COMMENT RESPONSE LETTER

Group: SP 2ND 15

Type: **CONST PLANS - ENVIRONMENTAL 15**

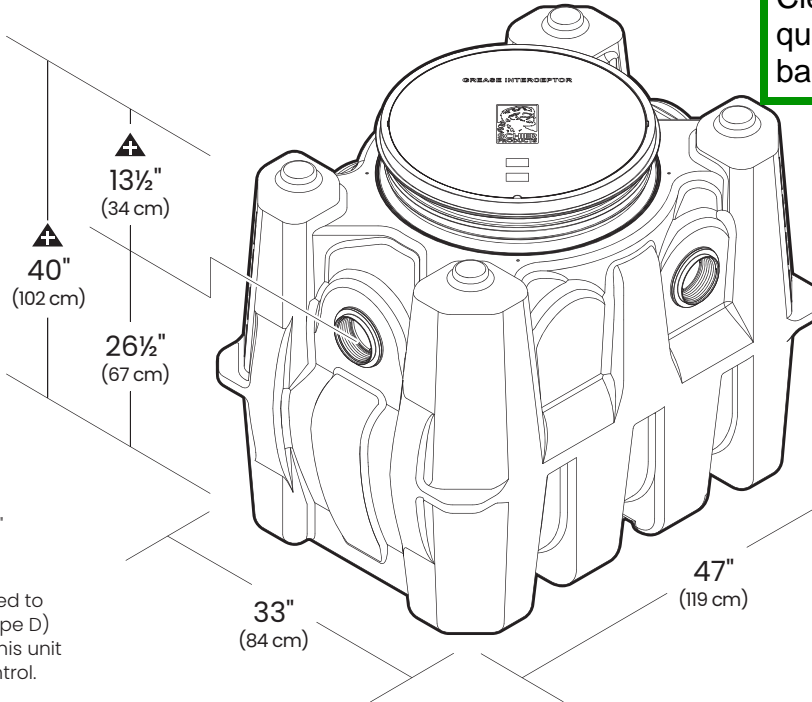
The proposed retaining wall is not permitted to encroach into the 5' utility easement. The EUSERC/Metering facilities may not be enclosed.

Response: The proposed retaining wall does not encroach into the 5' utility easement, it is located just outside. Acknowledged, metering facilities will not be enclosed.

MODEL NUMBER:
GB-75

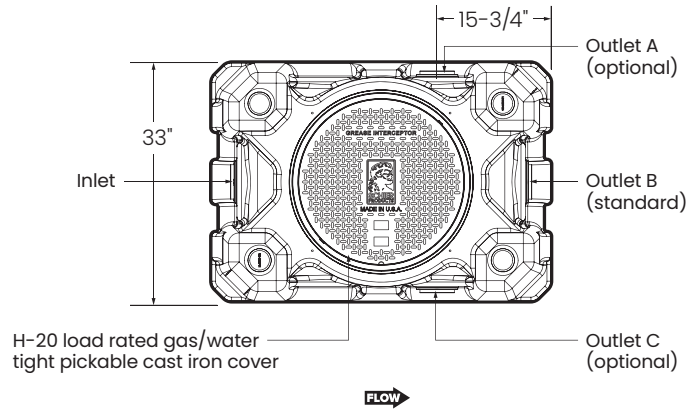
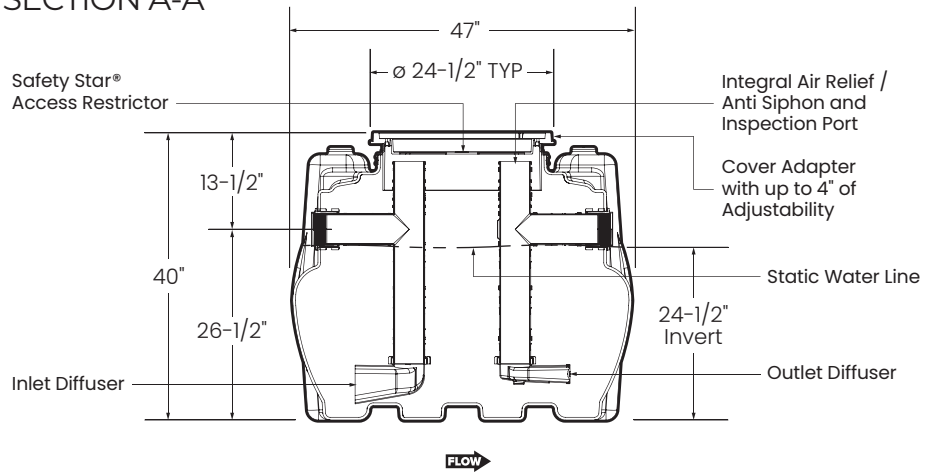
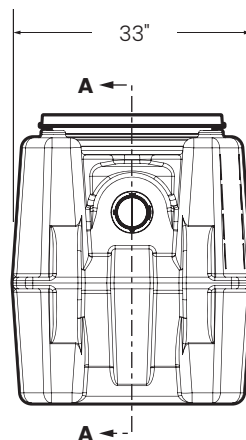
Please provide Interior Grease Interceptor design with a cleaning schedule.

Response: Comments have been addressed. Please see the attached document for greenline responses. Interior Grease Interceptor design with cleaning schedule detail has been added, see below. Plan and profile for proposed Force Main provided.

Cleaning schedule begins quarterly. Frequency is adjusted based off site history.
